Docket No. 50-271
BVY 04-098
TAC No. MC0761

Subject: **Vermont Yankee Nuclear Power Station**
Technical Specification Proposed Change No. 263 – Supplement No. 14
Extended Power Uprate – Response to Request for Additional Information

RELAP5 Nodalization Diagram

FIGURE
Vermont Yankee NSSS RELAP5 Model

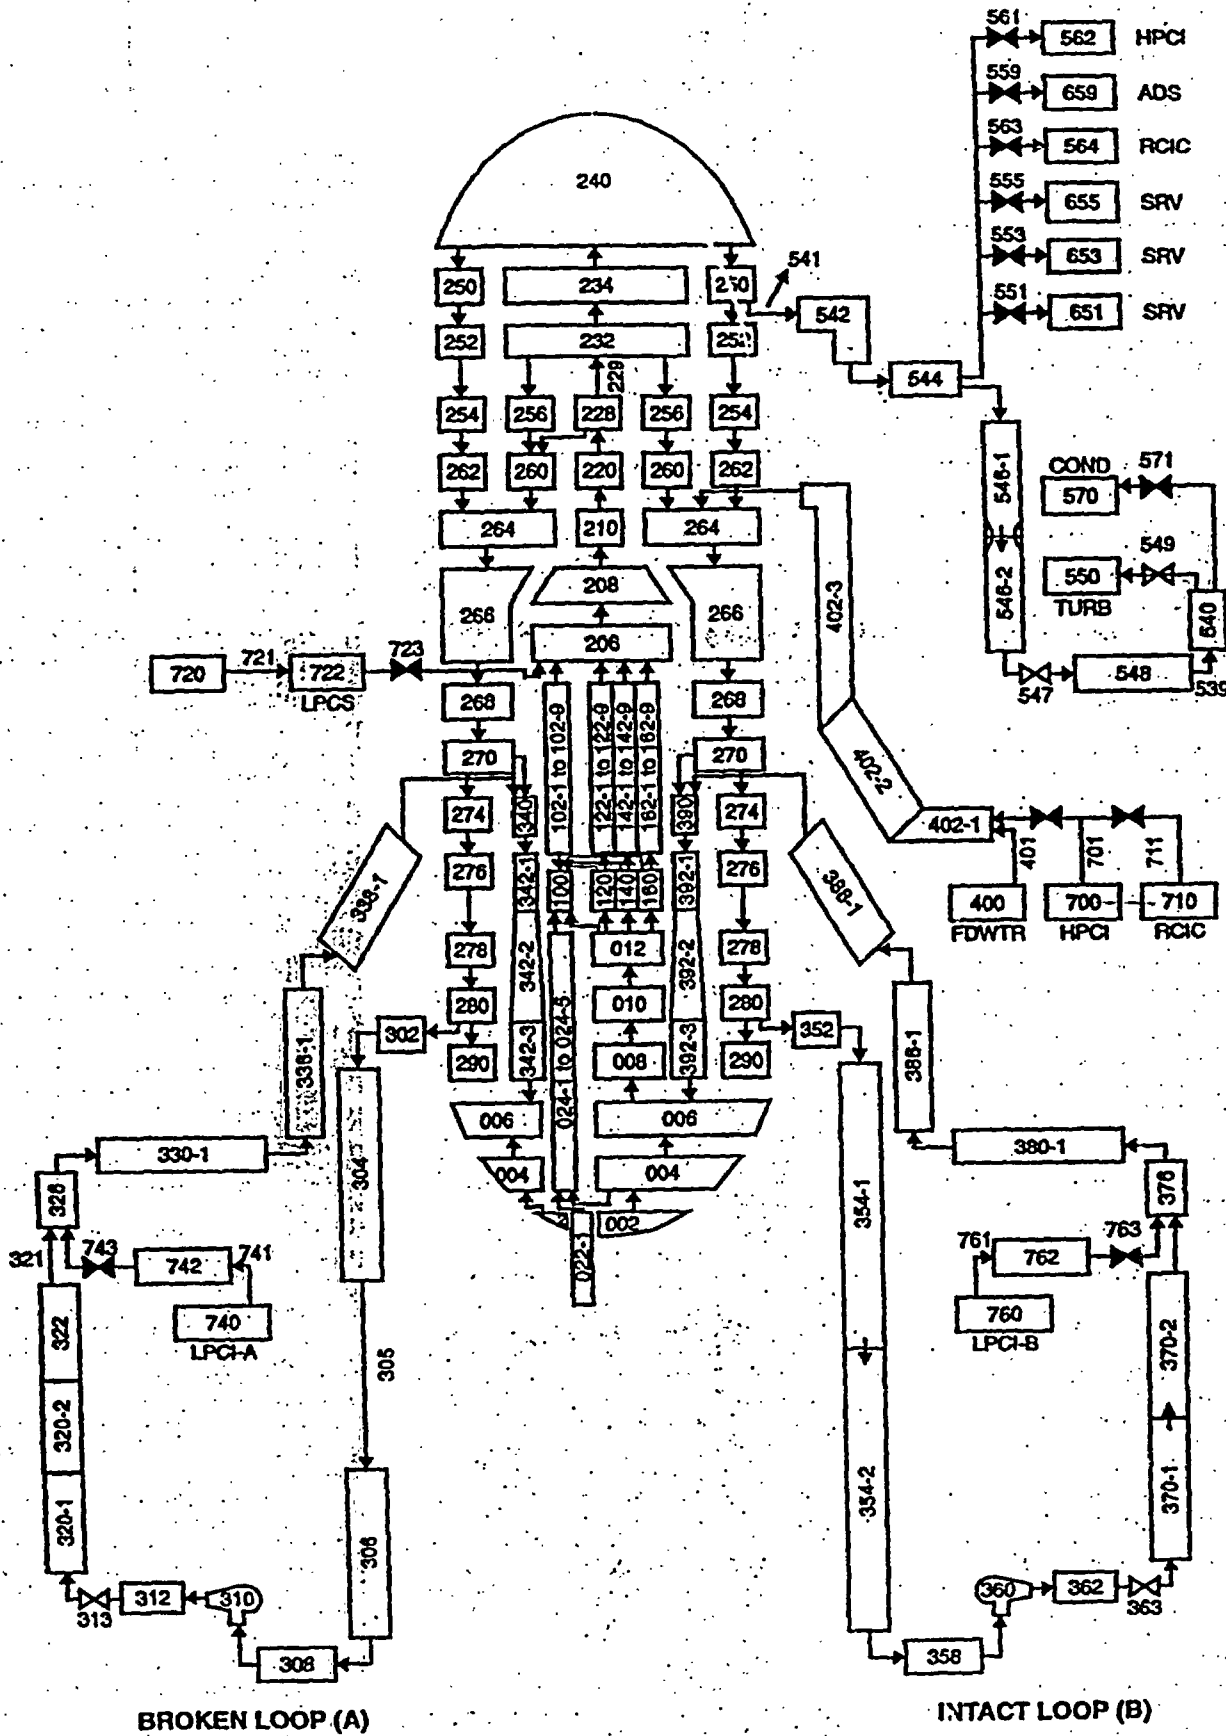
Attachment 1 is a RELAP5 nodalization diagram representation of the VYNPS nuclear steam supply system.
